## 7 Railway Street Chatswood

| Meeting   | <b>Railcorp Meeting</b>                                                                                                                                                                                                                        |
| Date      | <b>Friday 18 June 2010</b>                                                                                                                                                                                                                     |

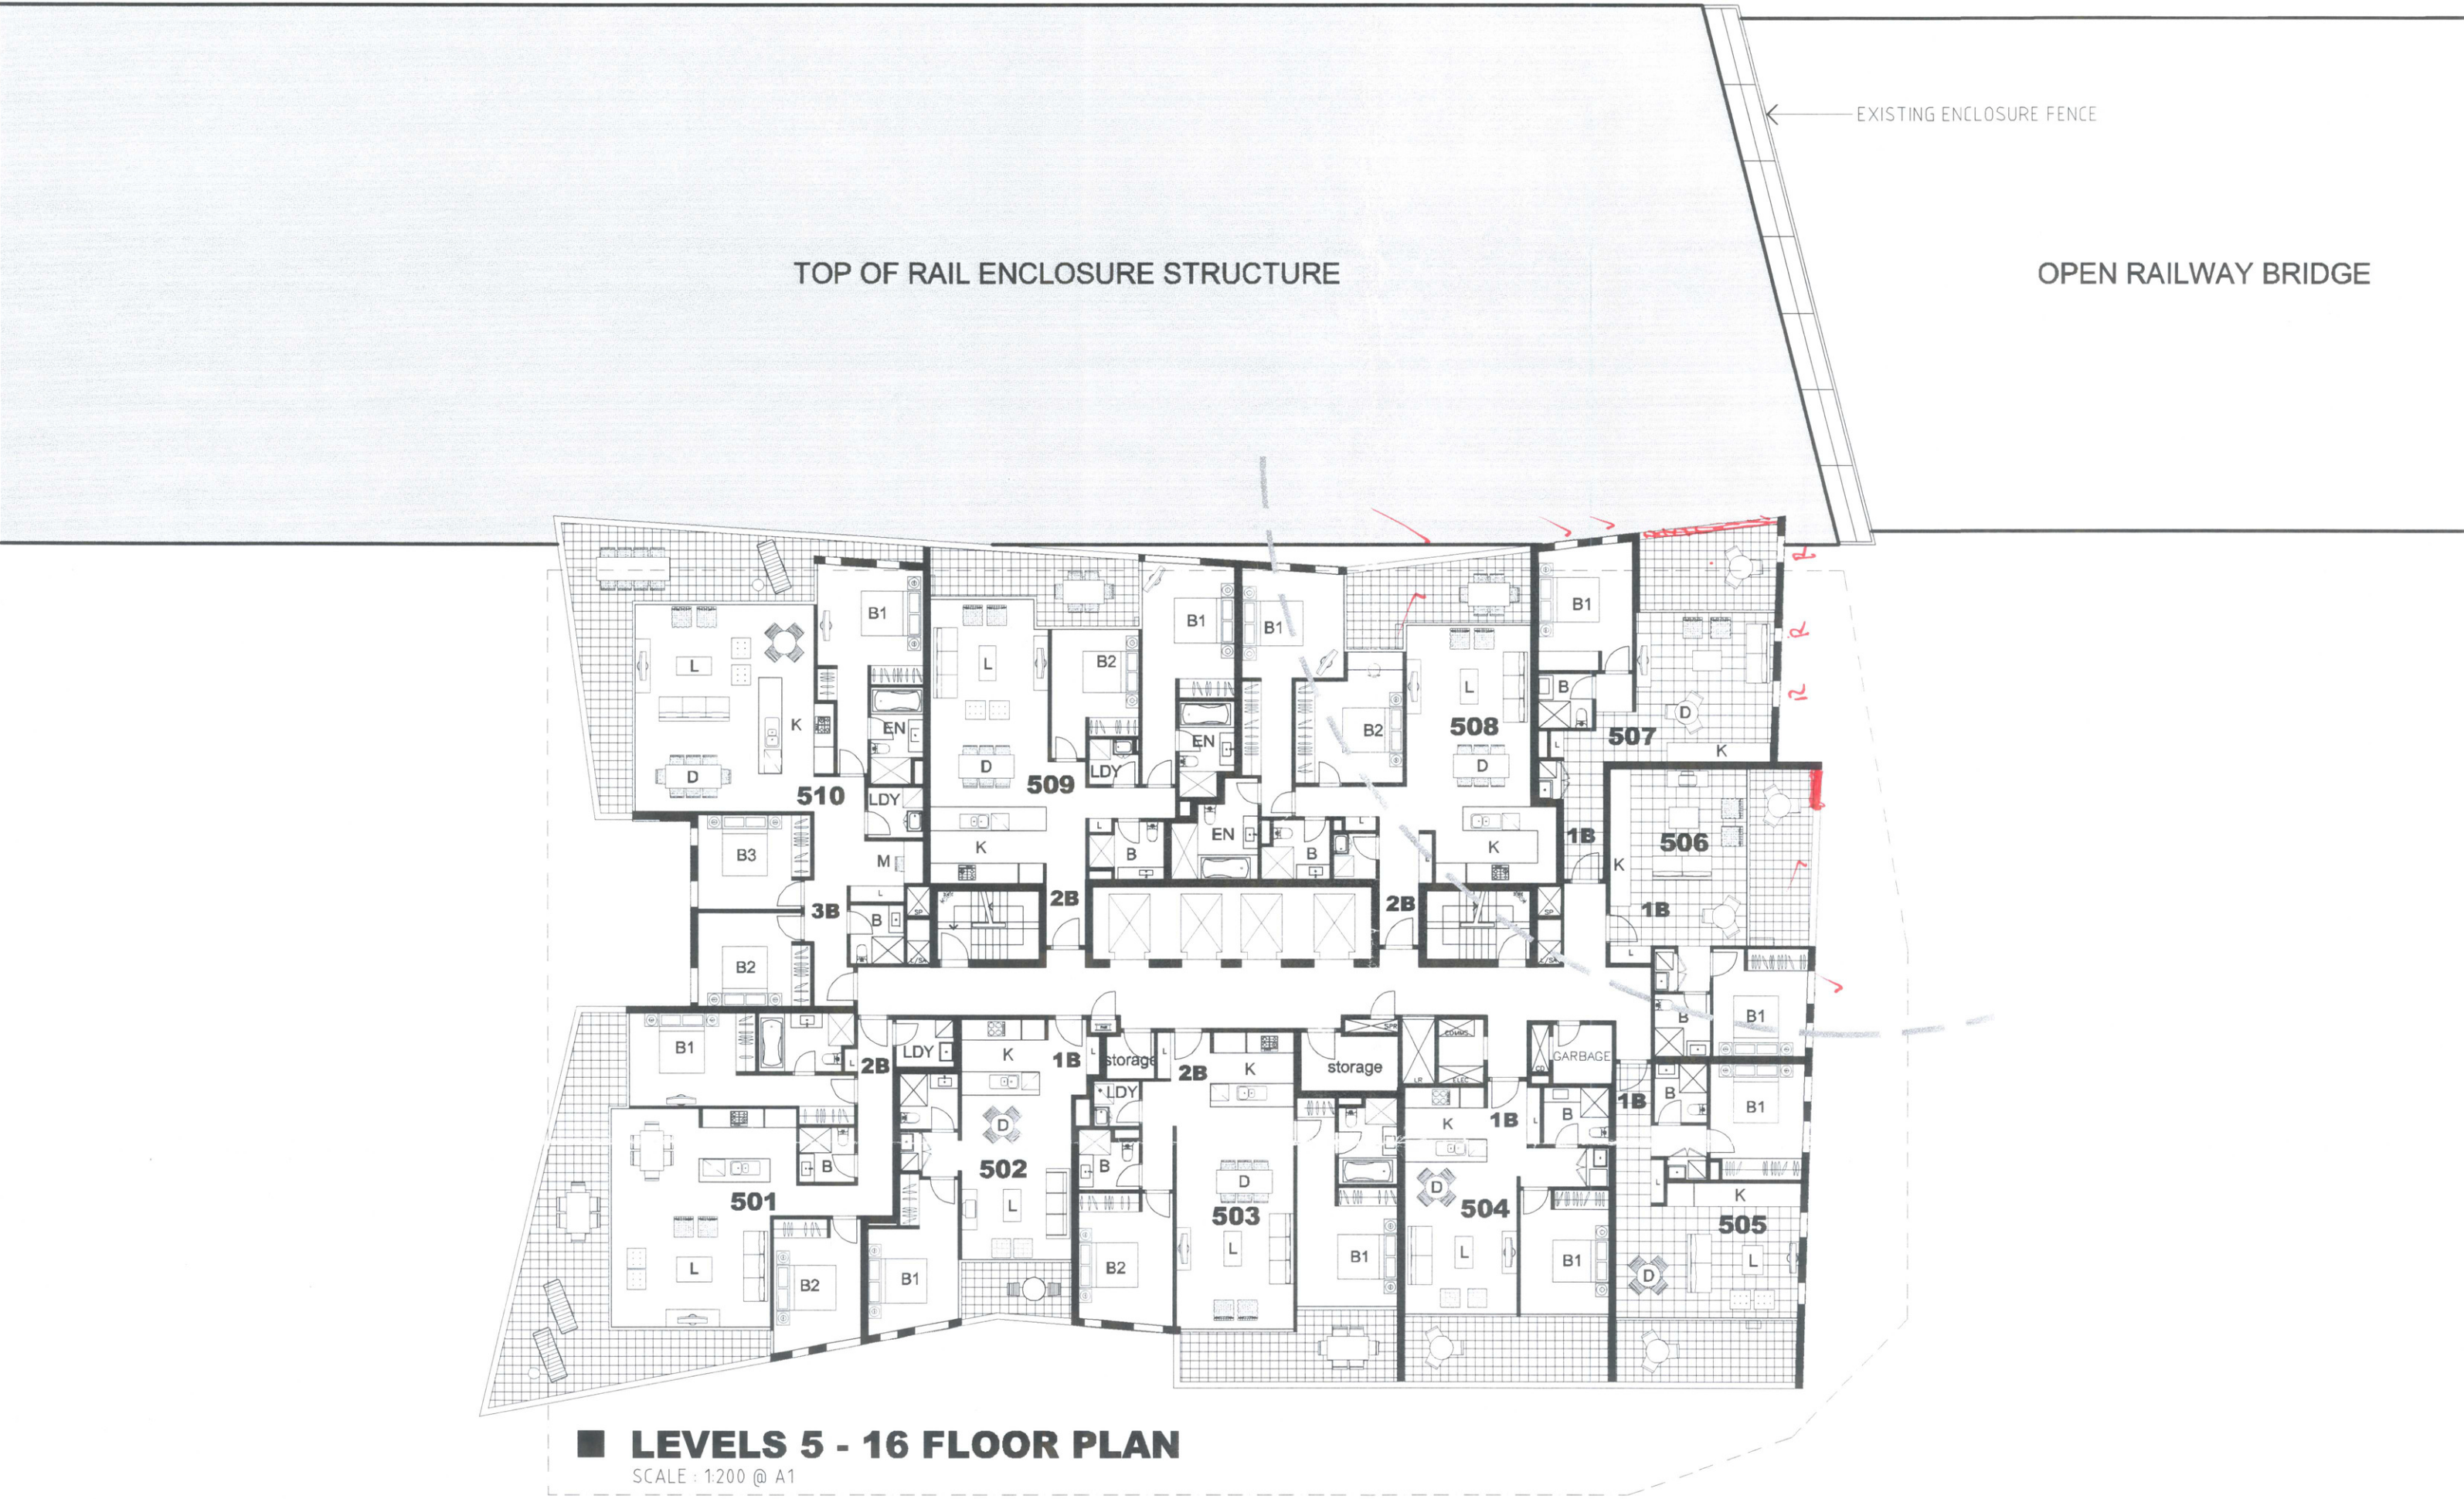
| Item | Description                                                                                                                                                                                                                                                                                                                                                                                                                                                                                                                                                                                                                                                                                                                                                                                                                                                                                                                                                                                                                                                                                   | Action                             |
|------|-----------------------------------------------------------------------------------------------------------------------------------------------------------------------------------------------------------------------------------------------------------------------------------------------------------------------------------------------------------------------------------------------------------------------------------------------------------------------------------------------------------------------------------------------------------------------------------------------------------------------------------------------------------------------------------------------------------------------------------------------------------------------------------------------------------------------------------------------------------------------------------------------------------------------------------------------------------------------------------------------------------------------------------------------------------------------------------------------|------------------------------------|
|      | <p>high rise) and by orientating the east facing façade on a splay away from the uncovered rail corridor.</p> <p>Mirvac / Railcorp reviewed the apartments and marked up the attached plan showing the extent of louvres and/or screening required to balconies “facing” the uncovered rail corridor and the windows requiring restrictors. In summary:</p> <ul style="list-style-type: none"> <li>- Apartment 507 (Low Rise): Enclosure of balcony and restrictors on windows to southern façade</li> <li>- Apartment 506 (Low Rise): Fixed louvres and/or screening approx. 500mm in length to south-eastern portion of balcony (as marked)</li> <li>- Apartment 1705 (Mid Rise): Fixed louvres and/or screening approx 4000mm in length to eastern portion of balcony in front of the living room (as marked) and restrictors to south facing windows</li> <li>- Apartment 2605 (High Rise): Solid blade wall to south-east balustrade adjacent to Bed 2 and fixed louvres and/or screening approx 4000mm in length to eastern portion of balcony in front of Bed 2 (as marked)</li> </ul> | <p>Agreed by Mirvac / Railcorp</p> |
